Memorandum

Subject: Response to Agency Comments on Norwood Multi-family Plan Amendments PMA-0001 & PTA23-0001

Date: 5/25/2023
To: Madeleine Nelson – Assistant Planner, City of Tualatin
From: Austin Cole, PE
Project Name: Norwood Multi-Family Plan Amendments (PMA-0001 & PTA23-0001)
AKS Job No.: 8723
Project Site: 9300 SW Norwood Road, Tualatin, OR 97062
Subject: Stormwater Downstream Impacts for City of Wilsonville

Figure 1 Basalt Creek Planning Area and jurisdictional boundaries.

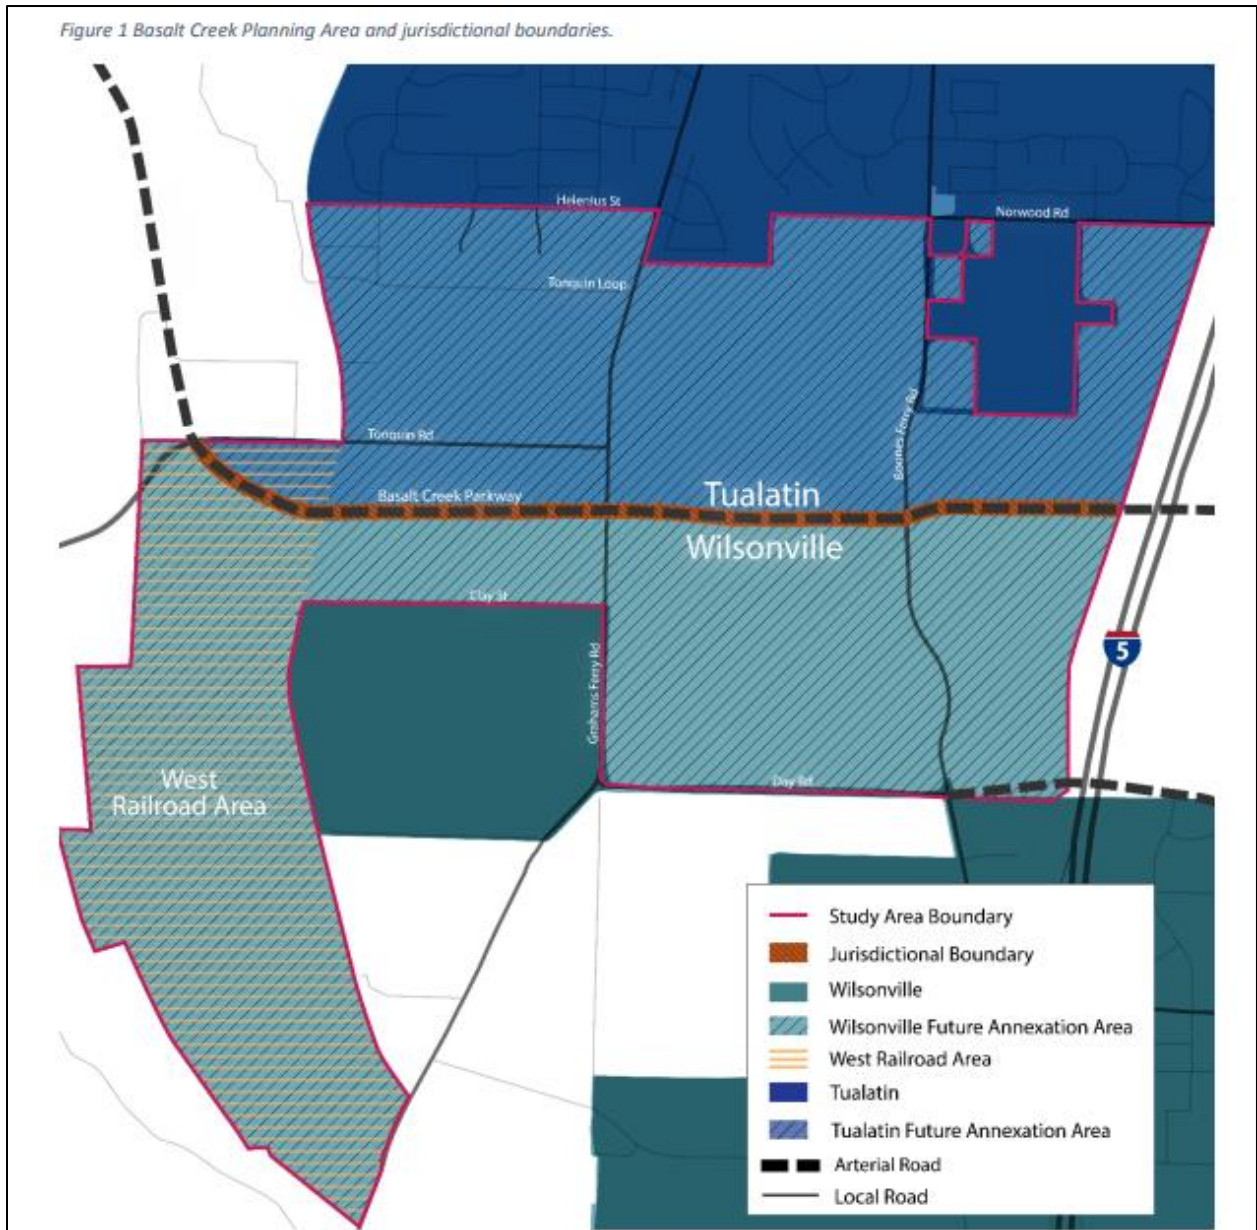
- The documentation should provide an updated analysis of the total planned trip generation in the Basalt Creek planning area under Tualatin’s jurisdiction compared to previous trip caps agreed to between Tualatin and Wilsonville during the Basalt Creek concept planning.

Response: The Basalt Creek planning area only includes the 1-acre portion of the Norwood Apartments site that is currently zoned Medium Low Density Residential (RML). The remainder of the site, which is zoned Institutional (IN) lies outside the planning area, as shown in Figure 1 from the Basalt Creek Concept Plan.

The TPR analysis assumed the maximum density under both the existing and proposed zoning. For the existing Medium Low Density Residential (RML) zoning, maximum density is 25 attached homes for the 1-acre parcel. For the proposed High Density/High Rise Residential (RH-HR) zoning, maximum density is 30 apartments for the 1-acre parcel.

As shown in Table 2, the net increase in trip generation for the 1-acre portion of the site with the proposed zone change in the Basalt Creek planning area is 1 evening peak hour trip and 22 daily trips.

The original Basalt Creek Concept Plan Adopted August 13, 2018, by the City of Tualatin included an estimated 1,111 PM peak hour trips for lands under Tualatin jurisdiction by the year 2035. The proposed zone change would have a negligible effect on the trip forecasts.

A supplemental transportation analysis conducted in 2019 evaluated the year 2040 conditions with even more employment growth in the planning area for both Tualatin and Wilsonville; however, the study only summarized the land use assumptions and not the trip estimates. With five more years of growth, the trip estimates would be even higher than the year 2035 estimate. Again, the proposed zone change would have a negligible effect on the forecasts.

In conclusion, the proposal does not significantly change the land use assumptions or potential traffic generation in the Basalt Creek planning area.
